# Access Compliance Report

## Public Rights-of-Way

Intersection ID: 52928	Main Street: GRAY_OAK_LN	Cross Street: MAPLE_OAK_DR	Location: SE
ADA ID: D558852E1032	Ramp Type: Perp	Initial Pass/Fail: Fail	Overall Compliance: No
		Severity Score: 10

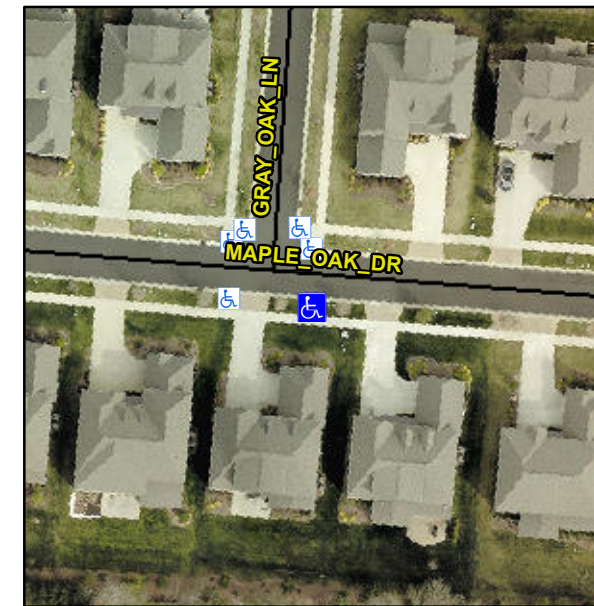
**Not Found, R304.5.1, R304.5.3**

Compliance	Description	Data	Compliance	Description	Data
N/A	Ramp Length (in)	96.0	Yes	Ramp Slope (%)	6.2
No	Ramp Width (in)	47.0	No	Ramp XSlope (%)	2.8
N/A	Flare Type LT	N/A	N/A	Flare Type RT	N/A
N/A	Flare Slope LT (%)	N/A	N/A	Flare Slope RT (%)	N/A
N/A	Flare Traversable LT?	N/A	N/A	Flare Traversable RT?	N/A
N/A	Landing Length (in)	N/A	N/A	DWS Provided?	N/A
N/A	Landing Width (in)	N/A	N/A	DWS Contrast?	N/A
N/A	Landing Slope (%)	N/A	N/A	DWS Length (in)	N/A
N/A	Landing X Slope (%)	N/A	N/A	DWS Full Width?	N/A
N/A	Landing Curb? (Y/N)	N/A	N/A	DWS Offset (in)	N/A
N/A	Shared Landing?	N/A			
N/A	Gutter Ponding?	N/A	N/A	Gutter Slope (%)	N/A
N/A	Gutter Lip Ht (in)	N/A	N/A	Gutter X Slope (%)	N/A
N/A	Painted X Walk1?	No	N/A	Painted X Walk2?	N/A
	X Walk 1 Direction	To N		X Walk 2 Direction	N/A
N/A	X Walk 1 Width (in)	N/A	N/A	X Walk 2 Width (in)	N/A
	X Walk 1 Slope (%)	3.3		X Walk 2 Slope (%)	N/A
	X Walk 1 X Slope (%)	2.7		X Walk 2 X Slope (%)	N/A

**Remove & Replace Entire Ramp.**
